ADDENDUM NO. 1

June 21, 2023

Renovations & Additions to Rockbridge Innovation Center

Project No. 21148
VA DOE PROJECT # 081-02-01-101

**ROOF FRAMING PLAN -
AREA A**

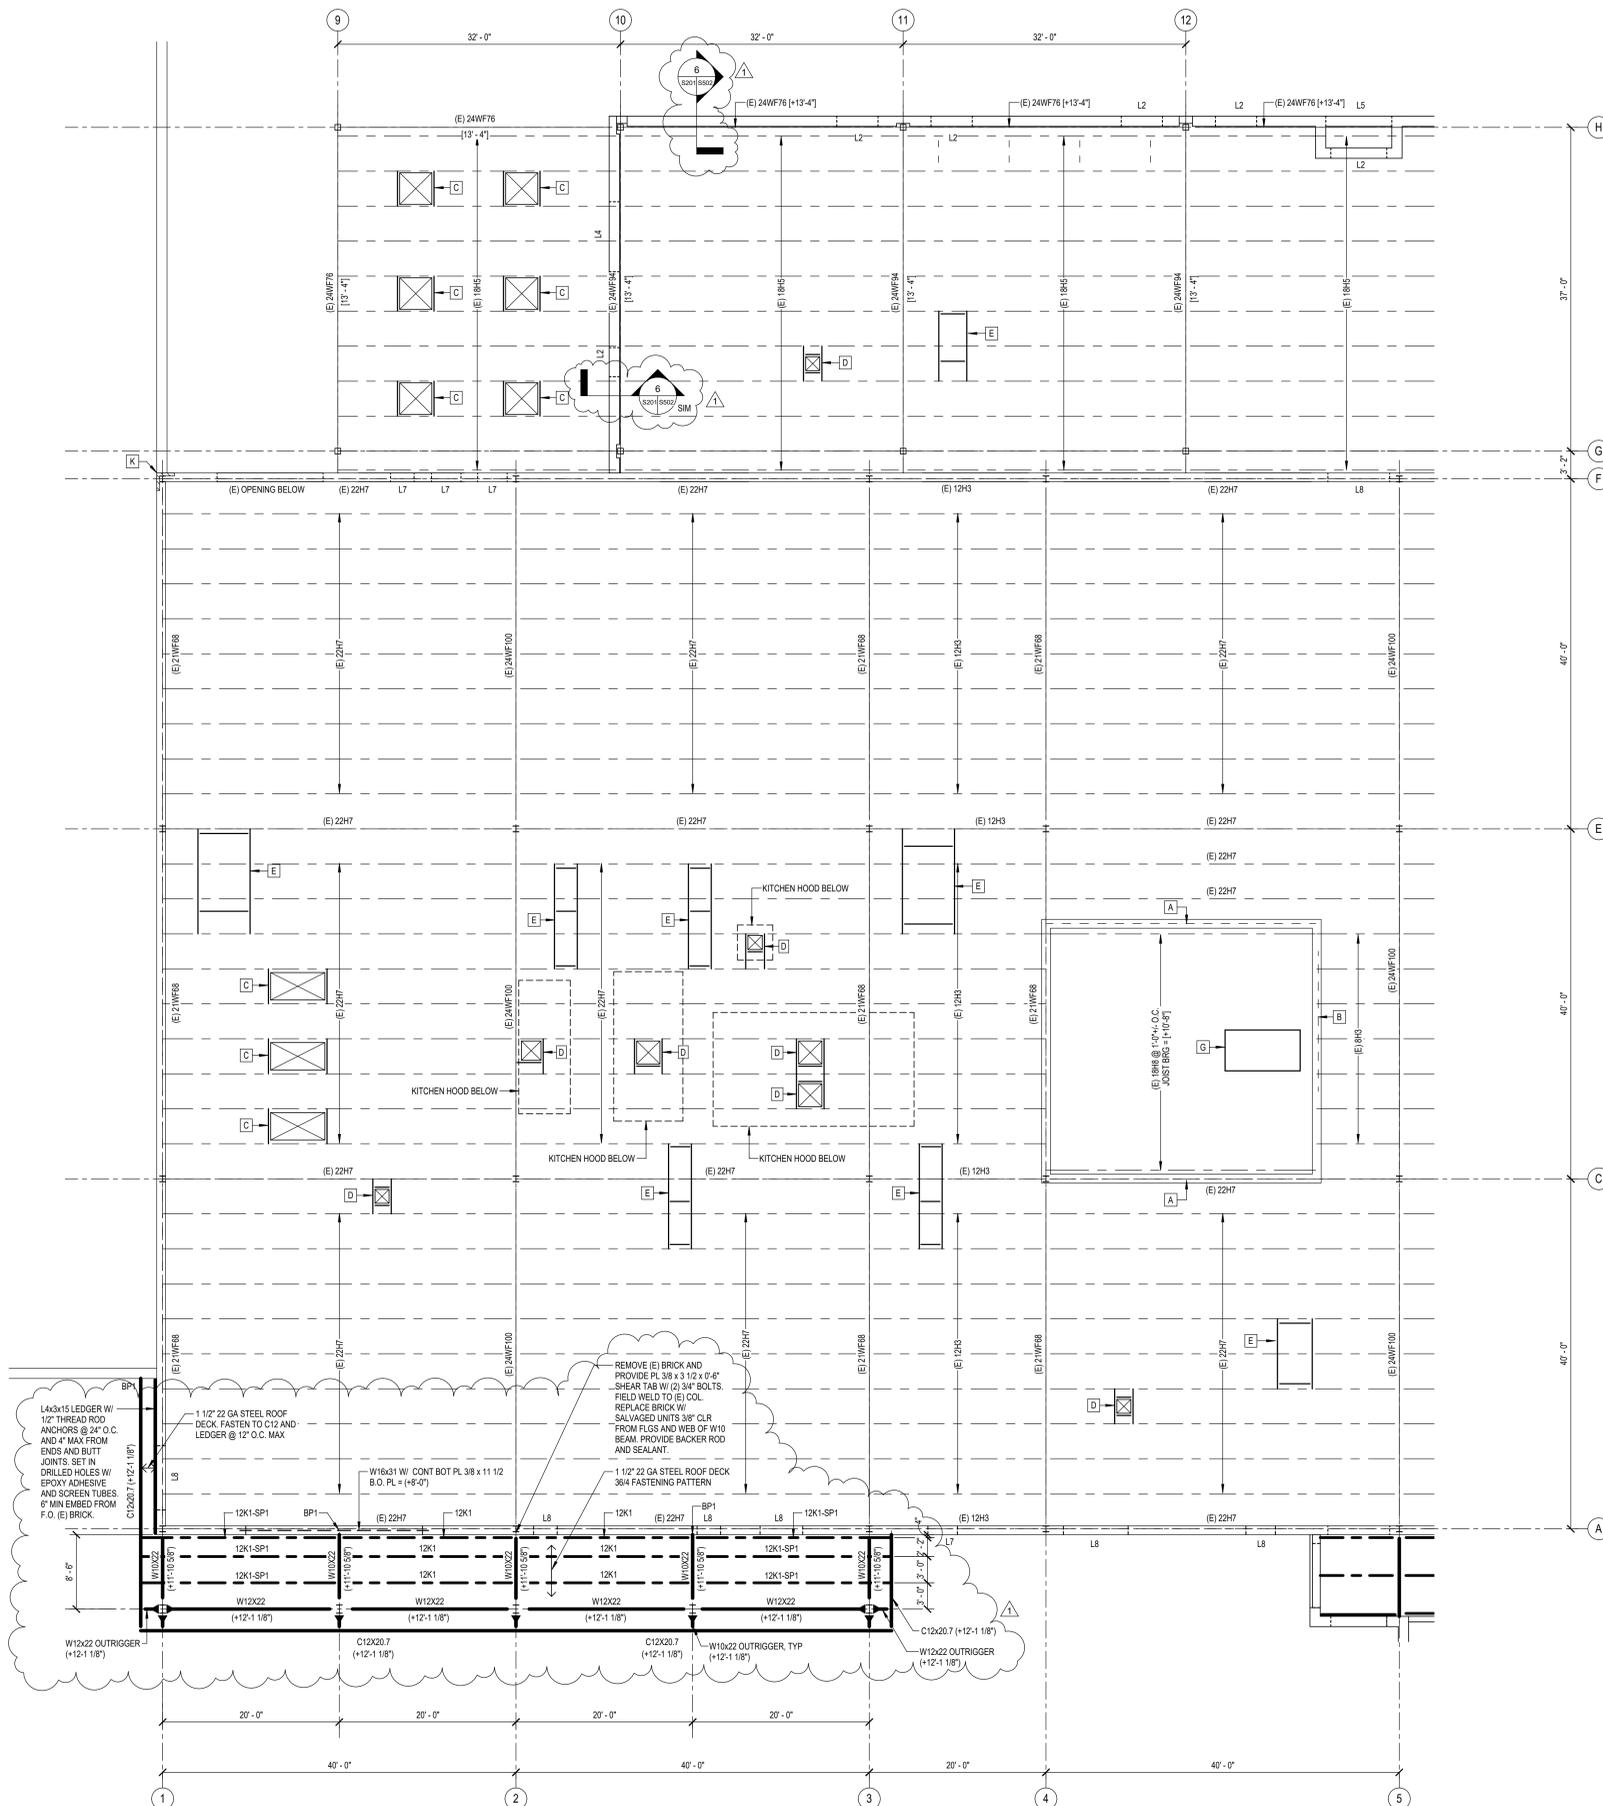
7. S201 – ROOF FRAMING PLAN – AREA A:
 - A. Replace sheet with attached revised sheet.
8. S202 – ROOF FRAMING PLAN – AREA B:
 - A. Replace sheet with attached revised sheet.

SHEET NAME:
**ROOF FRAMING PLAN -
AREA C**

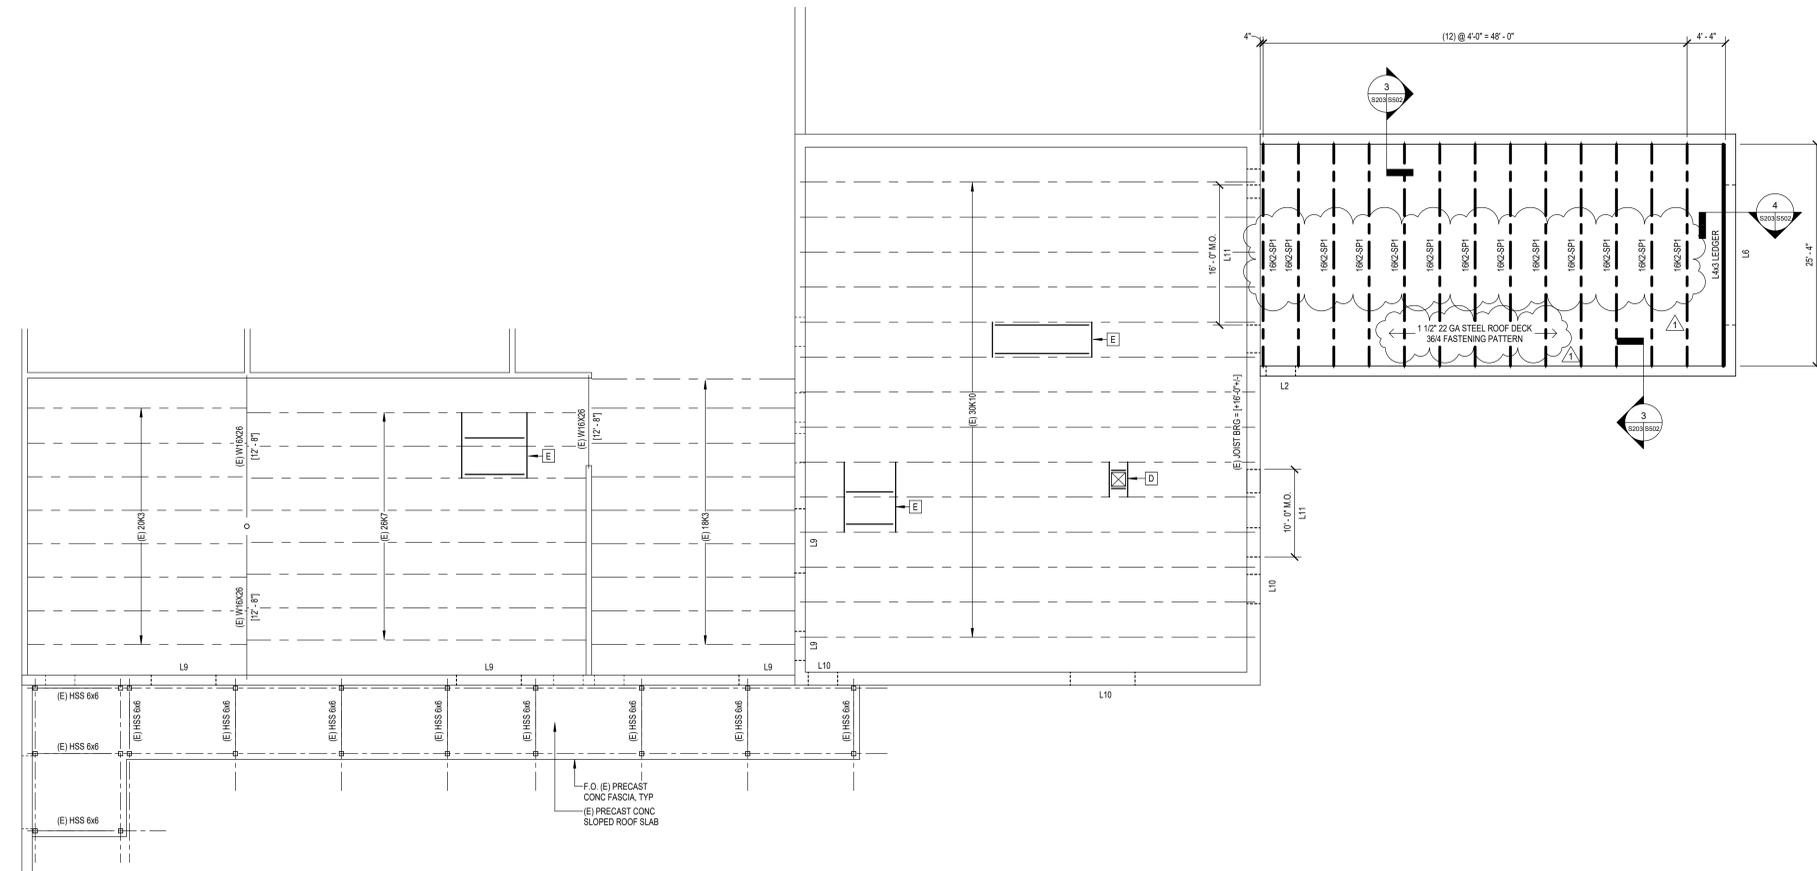
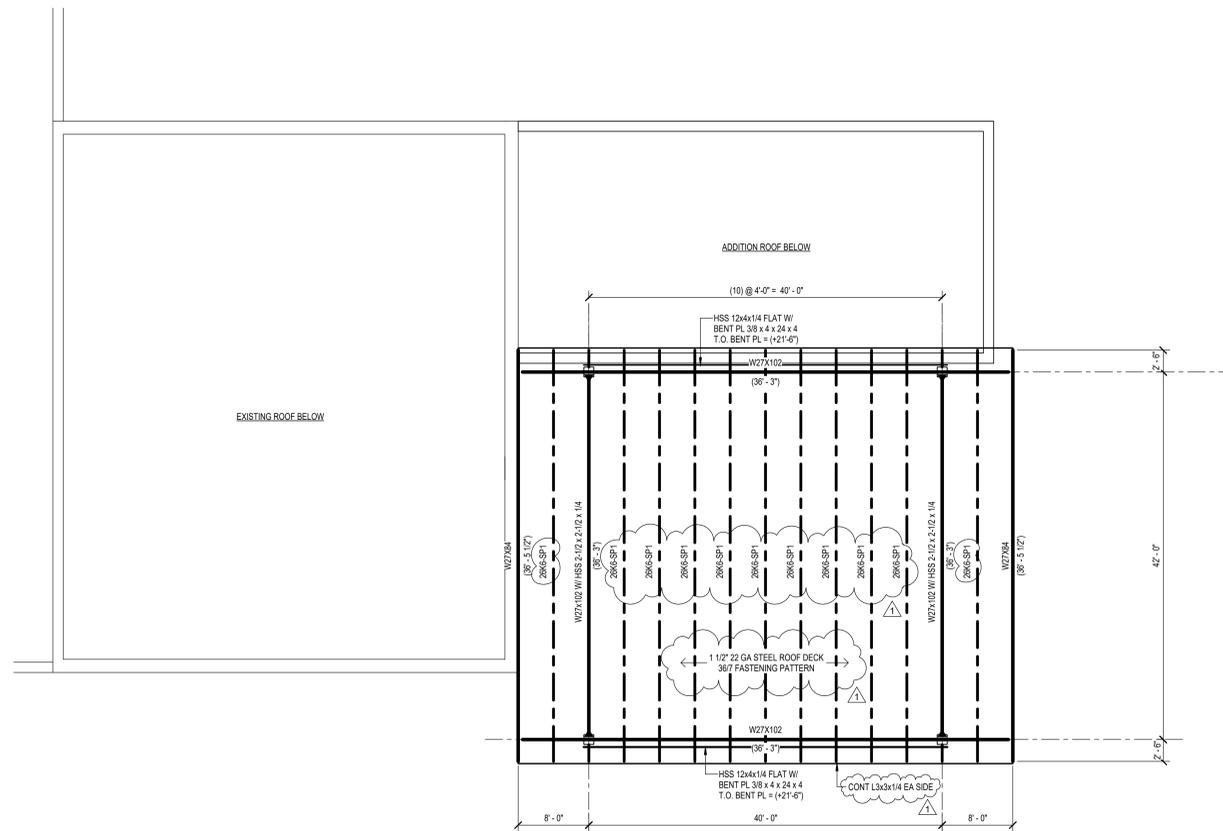
9. S203 – ROOF FRAMING PLAN – AREA C:
 - A. Replace sheet with attached revised sheet.
10. S502 – SECTIONS AND DETAILS:
 - A. Replace sheet with attached revised sheet.

PLAN NORTH
 SITE NORTH
 SHEET NAME:
**REFLECTED CEILING
 PLAN- AREA A**

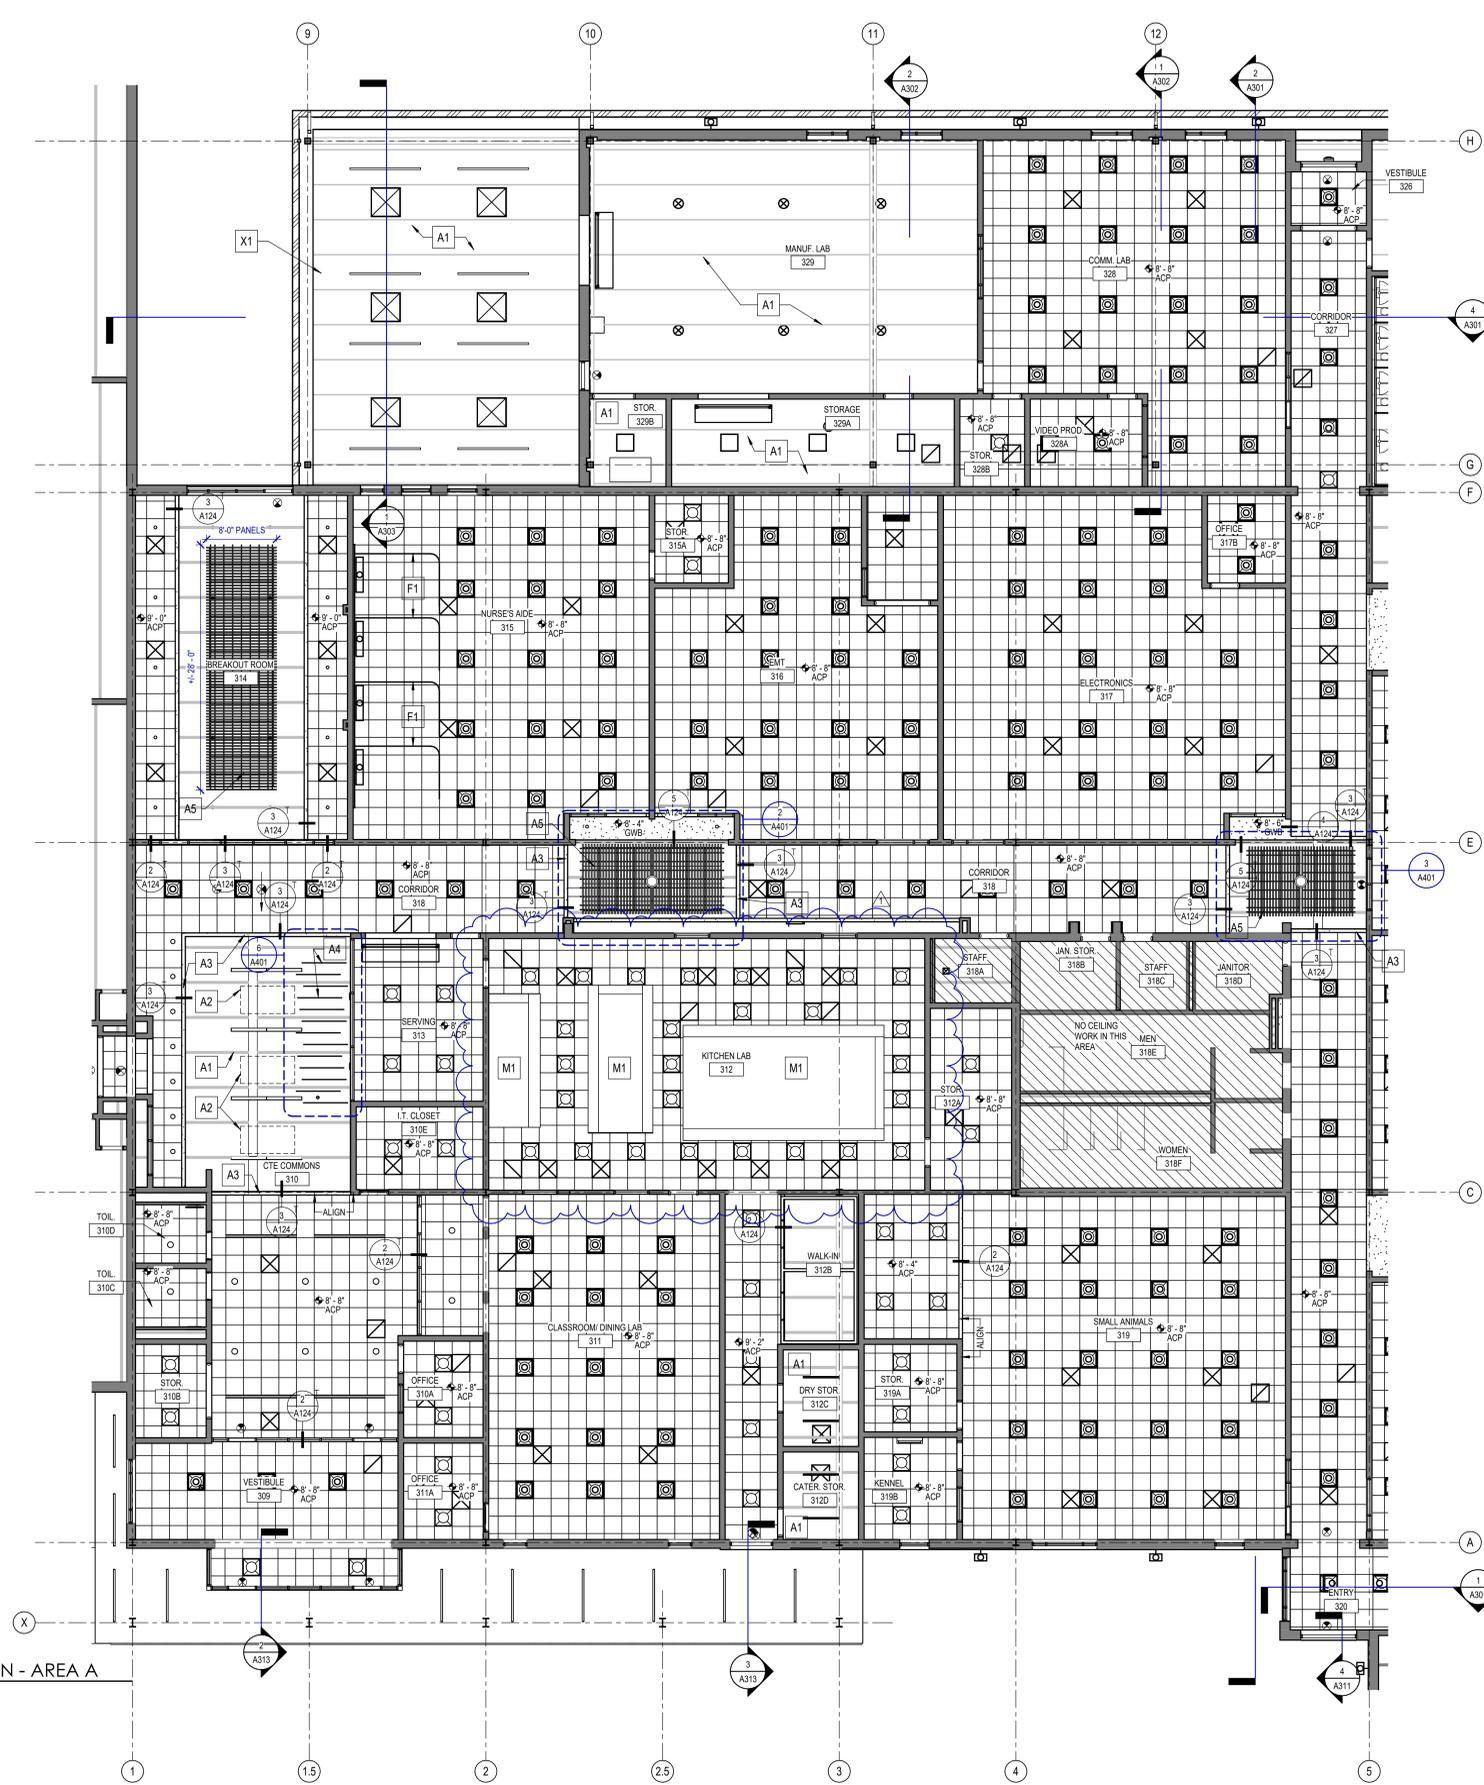
CMU pilaster has been added to the plan at the new Auto Body Lab (324) entrance. Refer to plan detail 2/A104.
15. A122- REFLECTED CEILING PLAN- AREA A: Replace sheet with attached revised sheet. Revised ceiling layout in Kitchen Lab (312).
16. A601- DOOR SCHEDULE & DETAILS: Replace sheet with attached revised sheet.

SCALE: N/A SHEET REF. NO.: E604

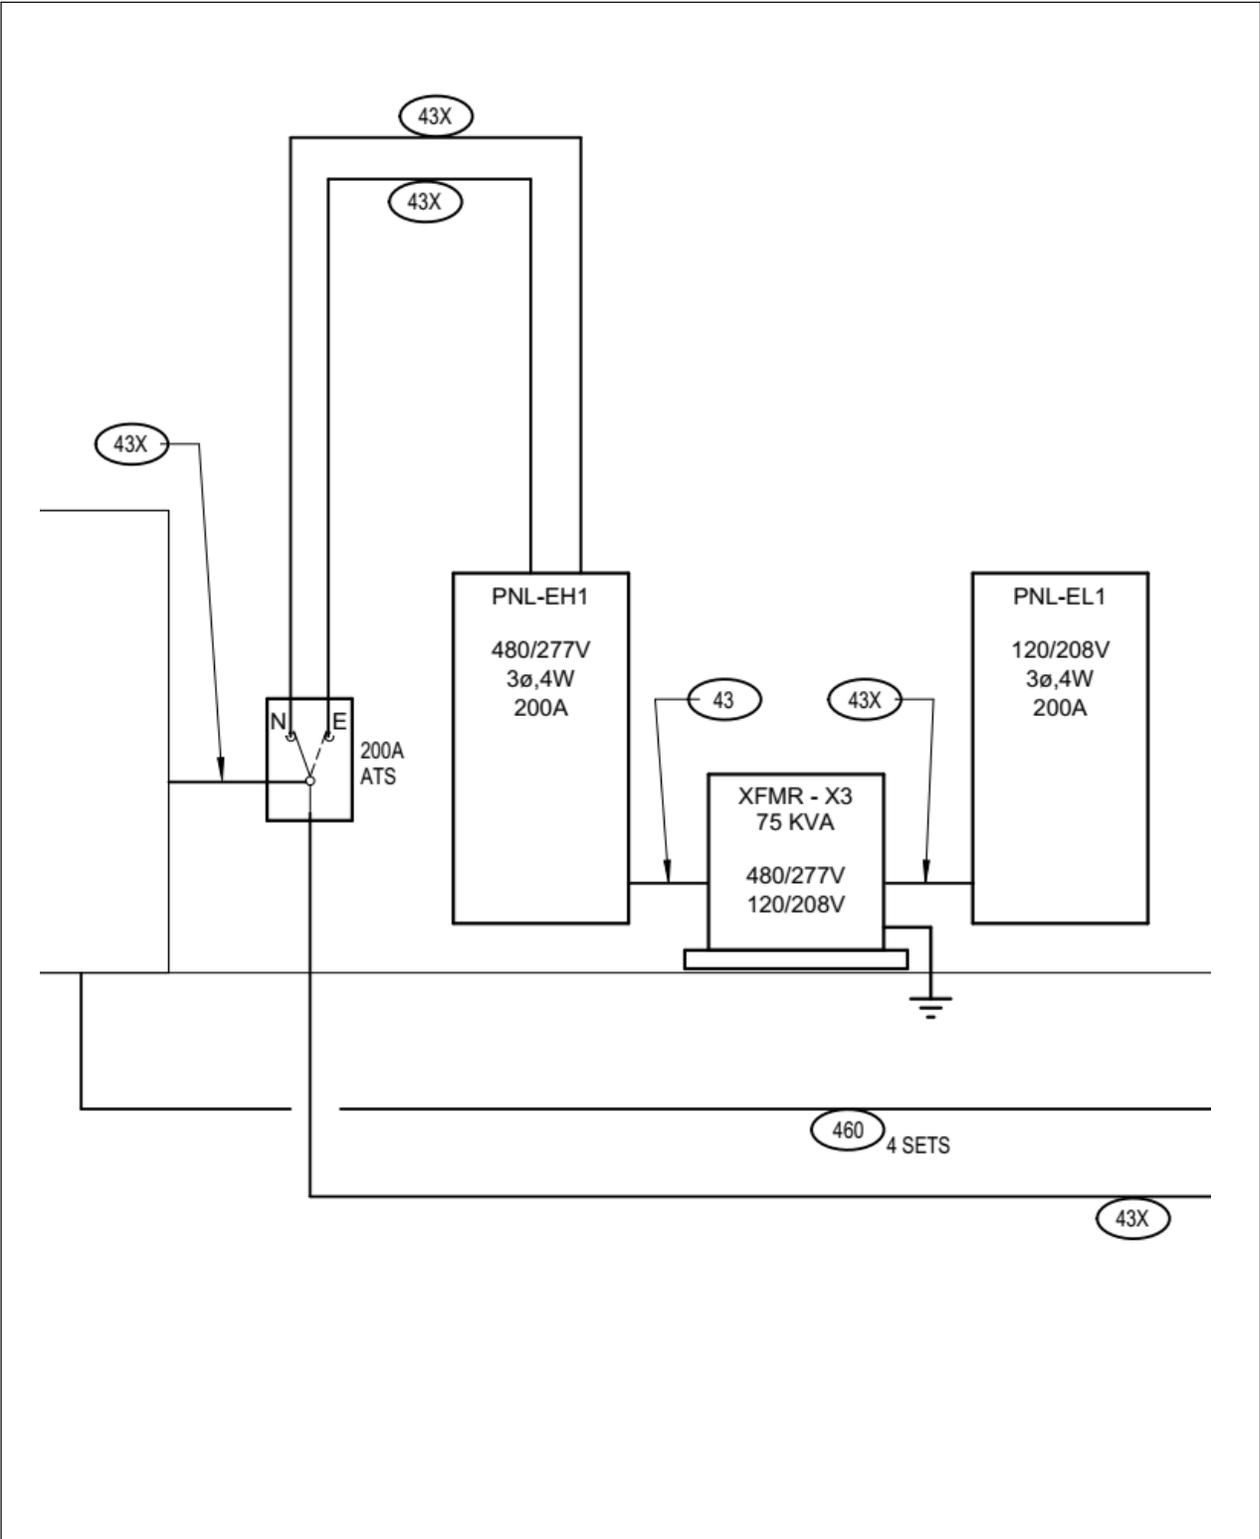
21. E604 – ELECTRICAL – PANEL SCHEDULES, Added branch circuits for generator jacket heater and battery charger to Panel EL1, Circuits 20 & 22. See sketch E4.
